SUBJECT: TURKEY POINT UNITS 3 AND 4 - ISSUANCE OF AMENDMENTS  
RE: THERMAL POWER UPRATE (TAC NOS. M94314 AND M94315)

The Commission has issued the enclosed Amendment No. 191 to Facility Operating License No. DPR-31 and Amendment No. 185 to Facility Operating License No. DPR-41 for the Turkey Point Plant, Unit Nos. 3 and 4, respectively. The amendments consist of changes to the Technical Specifications (TS) in response to your application dated December 18, 1995, as supplemented on May 3, June 11, July 1, July 3, and August 22, 1996.

The amendments increase the authorized rated thermal power from 2200 Megawatt-thermal (Mwt) to 2300 MWT. The amendment also approves changes to the TS to implement uprated power operation.

Figure 2.1-1 Reactor Core Safety Limit - Three Loops in Operation

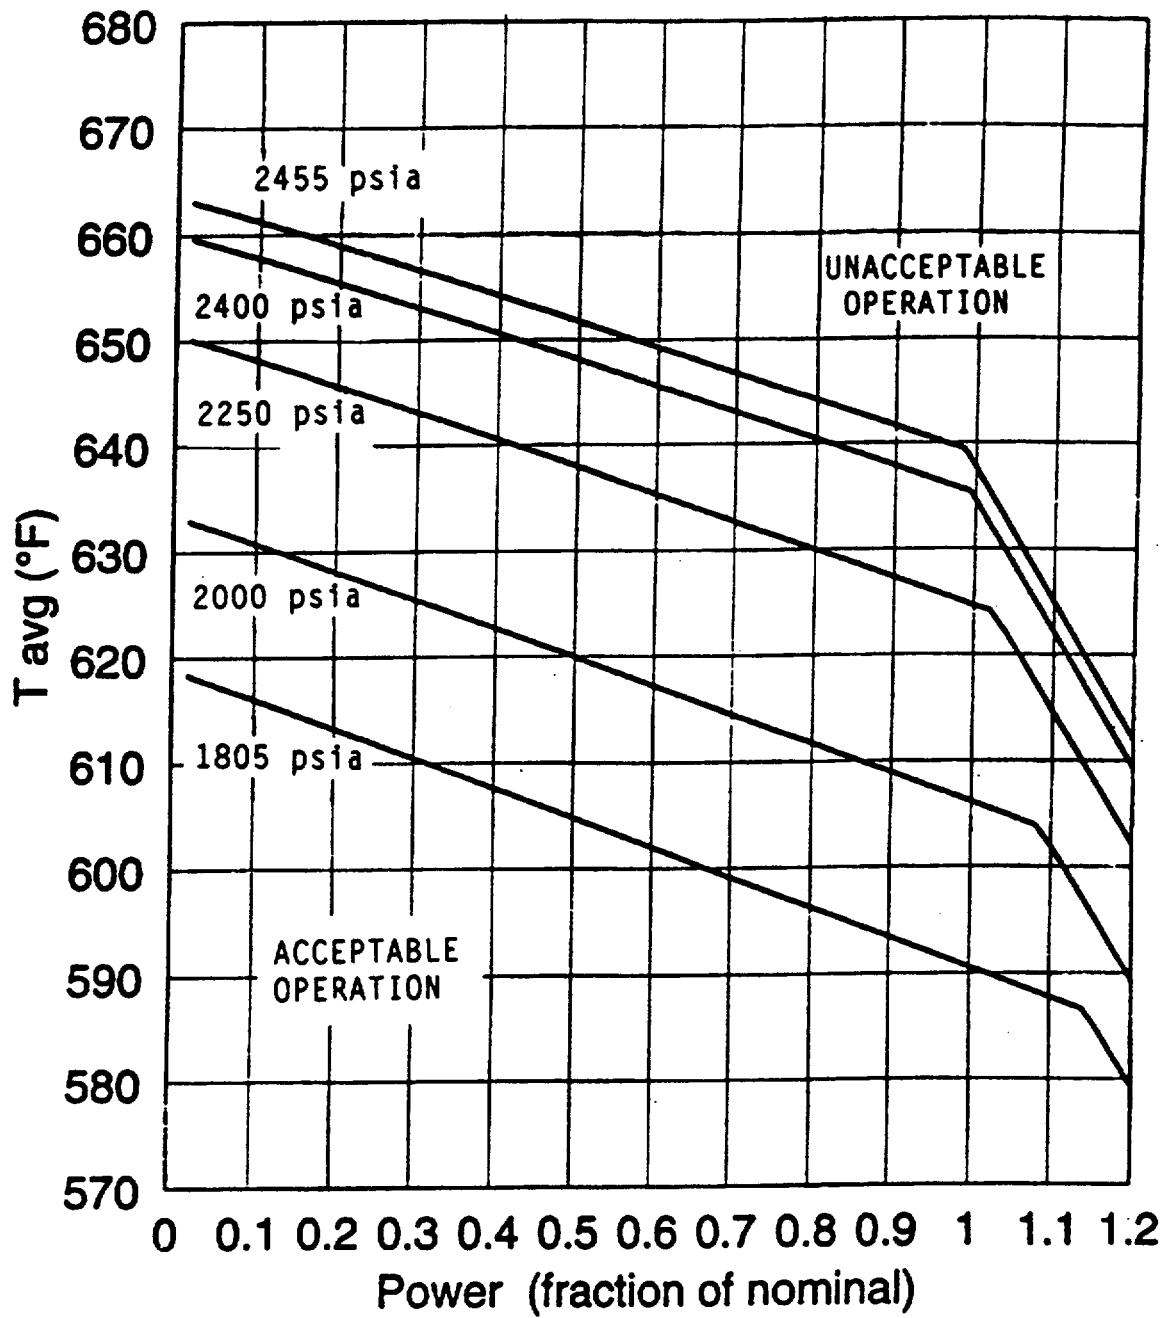
For TS Figure 2.1-1, "Reactor Core Safety Limits - Three Loops in Operation," the licensee proposed revising Figure 2.1-1 to reflect changes associated with the new operating conditions at the uprated power level.

Core safety limits for three loops in operation (TS Figure 2.1-1) have been revised to account for the proposed power uprating using the Revised Thermal

The revised core safety limits of TS Figure 2.1-1 required changes to the OT $\Delta T$  and OP $\Delta T$  setpoints. The use of the RTDP methodology and the inclusion of Turkey Point specific instrument uncertainties have resulted in revisions to the values associated with these trip function. These revised setpoints in the proposed TS were used in the accident analysis with acceptable results which are documented in WCAP-14276. The reduced RCS loop flow accounts for an analyzed increase in the percentage of steam generator tubes plugged (20 percent). The effects of the reduced RCS flow have been factored in the revised core safety limits. The reduced RCS flow has been assumed in the accident analysis with acceptable results which are documented in WCAP-14276.

**FIGURE 3.4-2**

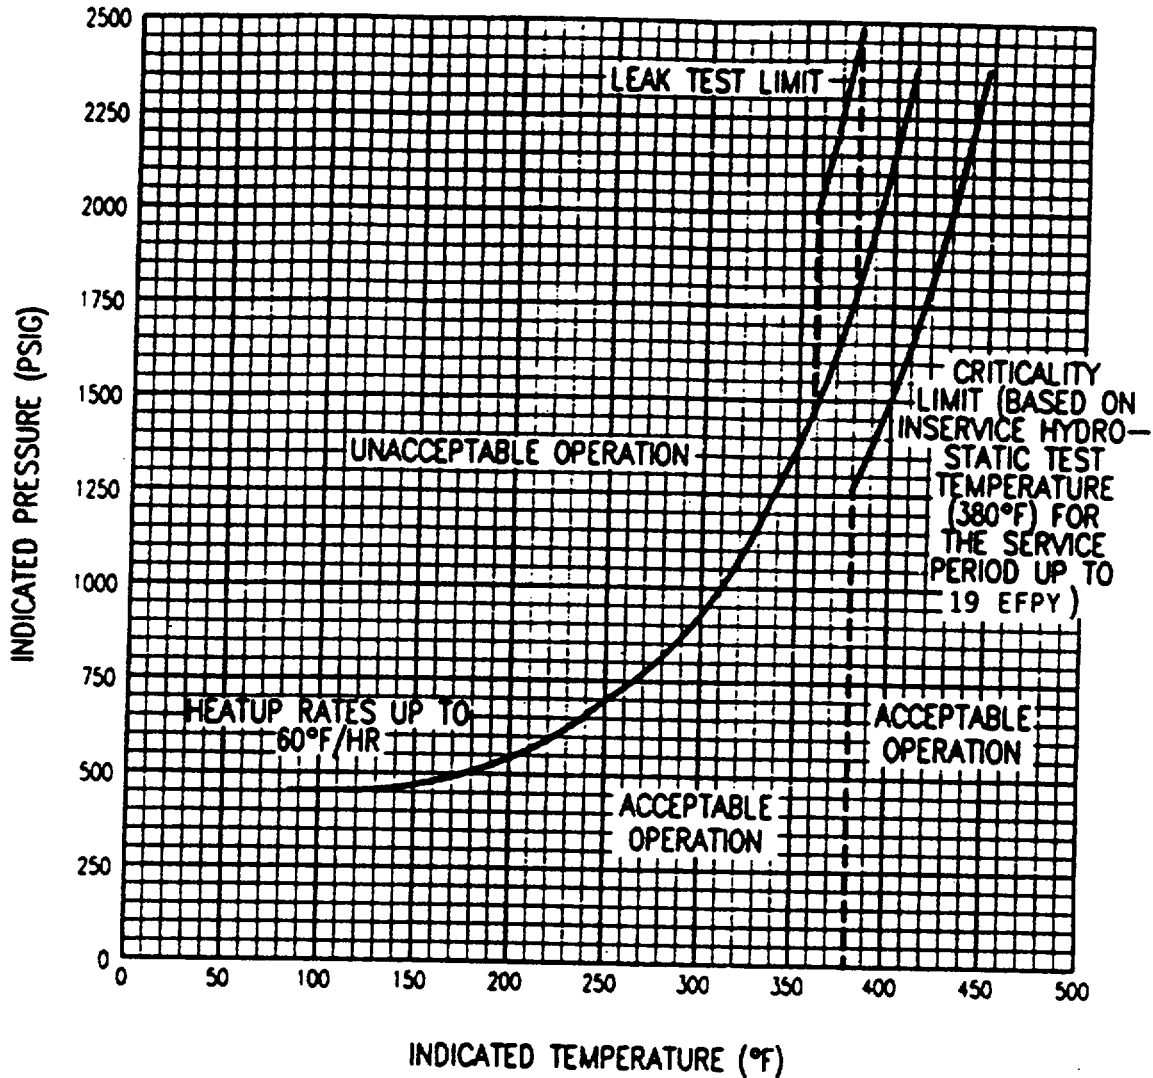
FPL proposed changes to TS Figure 3.4-2 - "RCS Heatup Limitations (60 °F/Hr)", TS Figure 3.4-3 - "RCS Heatup Limitations (100°F/Hr)", and TS Figure 3.4-4 - "RCS Cooldown Limitations (100°F/Hr)."
